Ref: Revisions to Phase 2 Decommissioning Plan
Docket No. 40-06563; License No. STB-401
Mallinckrodt, Inc., C-T Phase II Decommissioning Plan – Final

As requested in your May 21, 2010 letter, Mallinckrodt, Inc. is submitting three minor revisions to clarify the Decommissioning Plan. Changes have been made to incorporate the following revisions:

ST. LOUIS PLANT
 MONITORING WELL LOCATIONS
 FIGURE 3-8

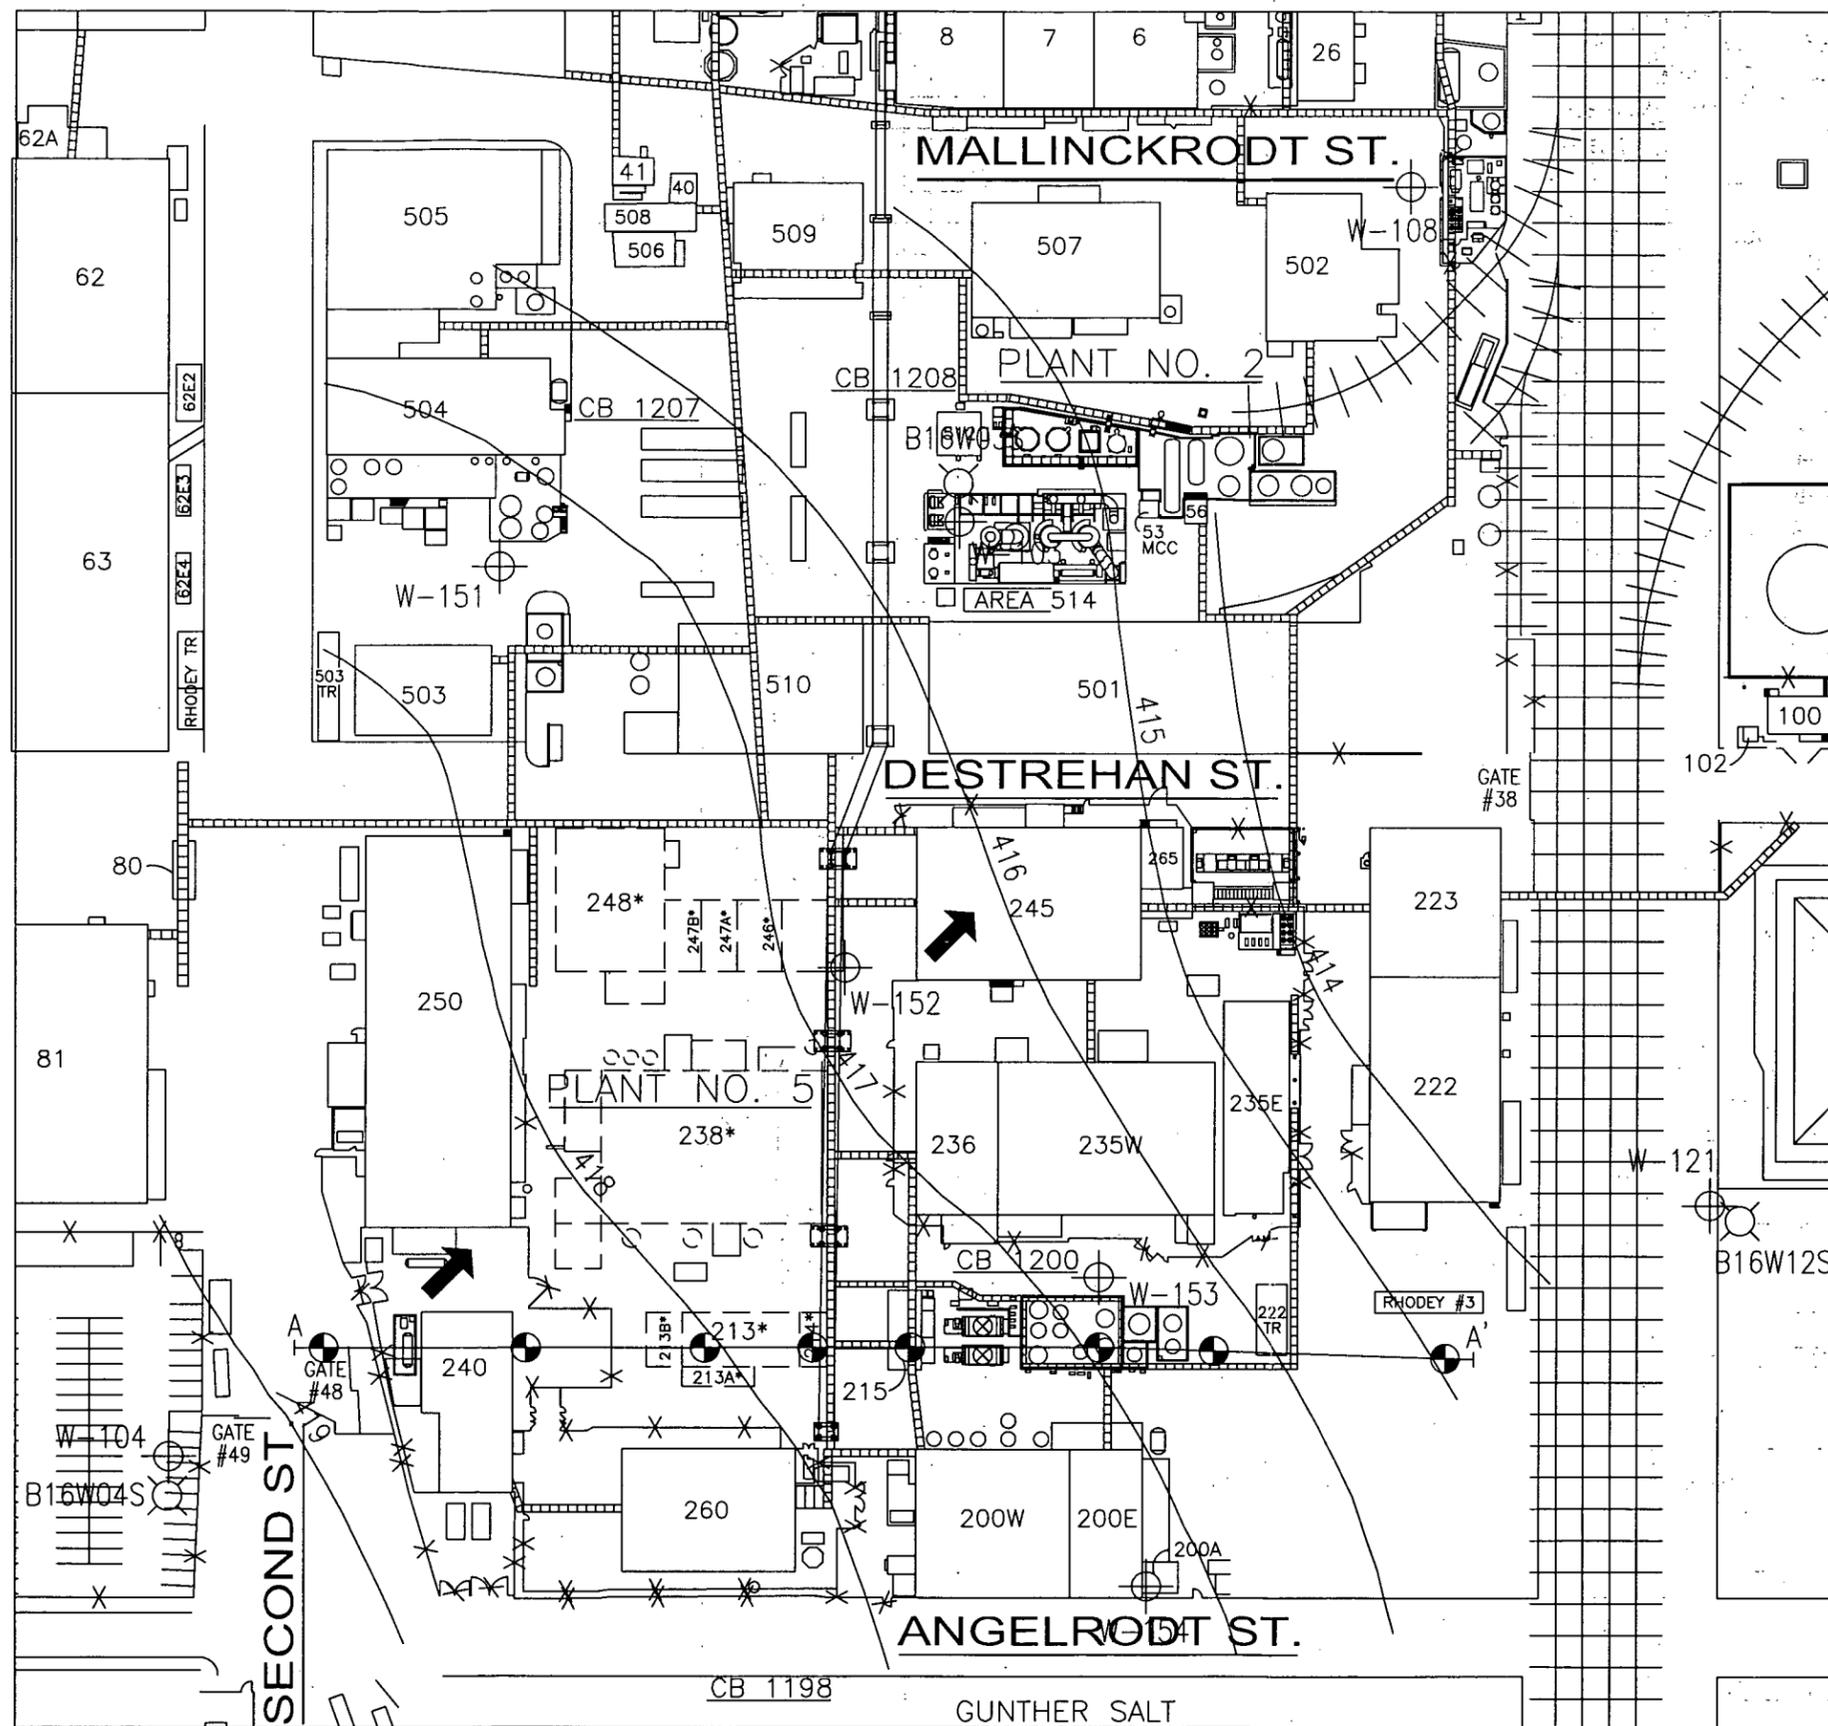
1. Section 12.2 revised to state that Mallinckrodt will notify NRC if filtered water samples from excavations contain radionuclides exceeding the U.S. Environmental Protection Agency groundwater maximum concentration limit (MCL).
2. Section 12.3 revised to include the following statement, "If hazardous chemicals or mixed waste are identified during decommissioning activities, Mallinckrodt will notify the State of Missouri Hazardous Waste Program Permit Section. Mallinckrodt will dispose of all hazardous chemical and mixed waste in accordance with appropriate state and federal regulations."
3. Figure 3-8, Monitoring Well Locations revised to include the reference to support the boring log data

NO.	DATE	ENGR.	DESCRIPTION
2	5/19/10		REVISED LEGEND INFO
1	03/31/03		GENERAL BACKGROUND UPDATING
